# Americans with Disabilities Act Accessibility Survey

## *Self-Evaluation and Transition Plan*

### Courthouse - Area B

**Prepared by**  
Sarpy County Facilities Management  
1210 Golden Gate Dr.  
Papillion, Nebraska 68046  
Ph. 402-593-2332  
Fax. 402-593-5793

North Curb Ramp Location

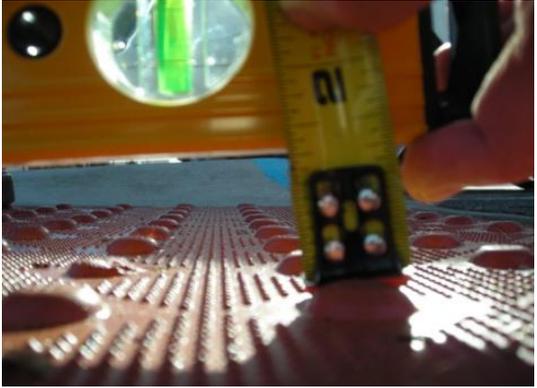
Code	405.2 Slope
Code Description	Ramp runs shall have a running slope not steeper than 1:12.
Finding	Running slopes of curb ramps range from 1:8 to 1:12.25.
Compliant?	<b>NO</b>
Recommended Repair (if needed)	Regrade ramp.

2.38 Continued.

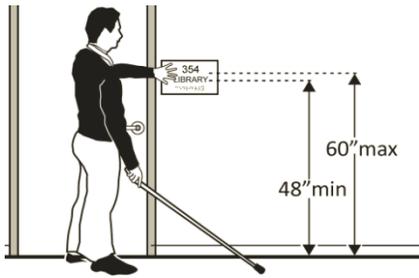
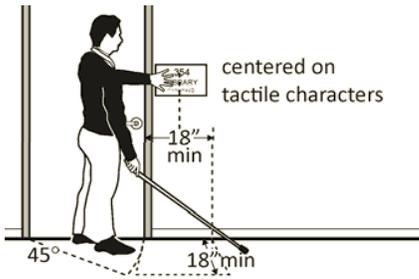
Finding	<p><b>Courtroom Signs:</b> Text characters contrast with their backgrounds; text characters are raised; there is Braille; signs are mounted on the latch side of the doors; there is sufficient clear floor space centered on the tactile characters; the baseline of the lowest character is at least 48" above the floor, and the baseline of the highest character is 63-1/4" above the ground.</p> <p><b>Other Room Signs:</b> No tactile room signs at Child Support or County Attorney.</p> <p><b>Exit Signs:</b> No tactile exit signs.</p>
Compliant?	<b>NO</b>
Recommended Repair (if needed)	Lower signs and install tactile signs.

Sign Height

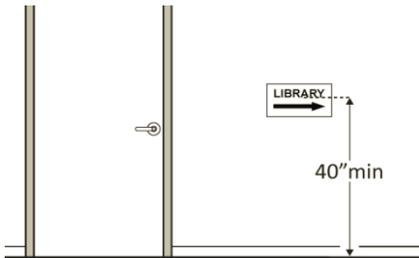
Code	703.5.1 Finish and Contrast; 703.5.5 Character Height
Code Description	703.5.1 - Characters and their backgrounds shall have a non-glare finish. Characters shall contrast with their background with either light characters on a dark background or dark characters on a light background. 703.5.5 - Minimum character height shall comply with Table 703.5.5. Viewing distance shall be measured as the horizontal distance between the character and an obstruction preventing further approach towards the sign. Character height shall be based on the uppercase letter "I". (See Table 703.5.5)
Finding	Text characters contrast with their backgrounds; <b>signs are not mounted so that characters are at least 40" above the floor.</b>
Compliant?	<b>NO</b>
Recommended Repair (if needed)	Raise signs.

2.39	Sign characters are too low.	Raise (11) signs.	\$500.00	2015-11		
2.41	Insufficient latch-side maneuvering clearance.	Reconfigure walls or add automatic door openers.	\$0.00	Alternate accessible route available.

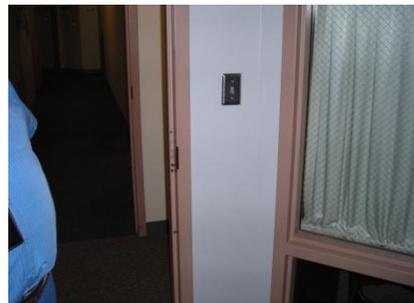
Code	404.2.4.1 Swinging Doors and Gates; 404.2.4.4 Floor or Ground Surfaces
Code Description	404.2.4.1 - Swinging doors and gates shall have maneuvering clearances complying with Table 404.2.4.1. (See Table 404.2.4.1) 404.2.4.4 - Floor or ground surface within required maneuvering clearances shall comply with 302. Changes in level are not permitted. EXCEPTIONS: 1. Slopes not steeper than 1:48 shall be permitted. 2. Changes in level at thresholds complying with 404.2.5 shall be permitted.
Finding	There is at least 18" of maneuvering clearance beyond the latch side plus at least 60" clear depth for all doors <b>except doors #1282B, 1254B, 1349, and 1380, which have less than 18" clearance beyond the latch side.</b>
Compliant?	<b>NO</b>
Recommended Repair (if needed)	Reconfigure walls or add automatic door openers.

Courtroom 7 Raised Floor

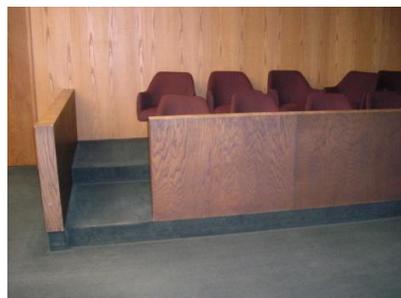
Code	808.2 Turning Space; 305.3 Size
Code Description	808.2 - Where provided, areas that are raised or depressed and accessed by ramps or platform lifts with entry ramps shall provide unobstructed turning space complying with 304. 305.3 - The clear floor or ground space shall be 30 inches minimum by 48 inches minimum.
Finding	<b>Courtrooms 6 &amp; 7:</b> There is no ramp. <b>Courtroom 8:</b> There is an unobstructed turning space measuring 40" by 60".
Compliant?	<b>NO</b>
Recommended Repair (if needed)	Install ramp with sufficient turning space.

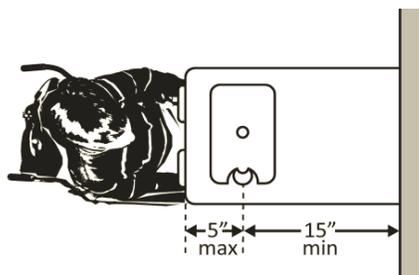
Code	602.5 Spout Location
Code Description	The spout shall be located 15 inches minimum from the vertical support and 5 inches maximum from the front edge of the unit, including bumpers.
Finding	The spout is 8" from the rear of the drinking fountain and 2" from the front of the drinking fountain.
Compliant?	<b>NO</b>
Recommended Repair (if needed)	Replace drinking fountain.

<b>4.6</b>	<i>Spout outlets are too high.</i>	<i>Replace drinking fountain.</i>	<i>See Courthouse - Area B, 4.2</i>		
<b>4.7</b>	<i>Spout is not far enough from rear of drinking fountain.</i>	<i>Replace drinking fountain.</i>	<i>See Courthouse - Area B, 4.2</i>		
<b>TOTAL</b>			<b>\$23,900.00</b>		<b>\$0.00</b>
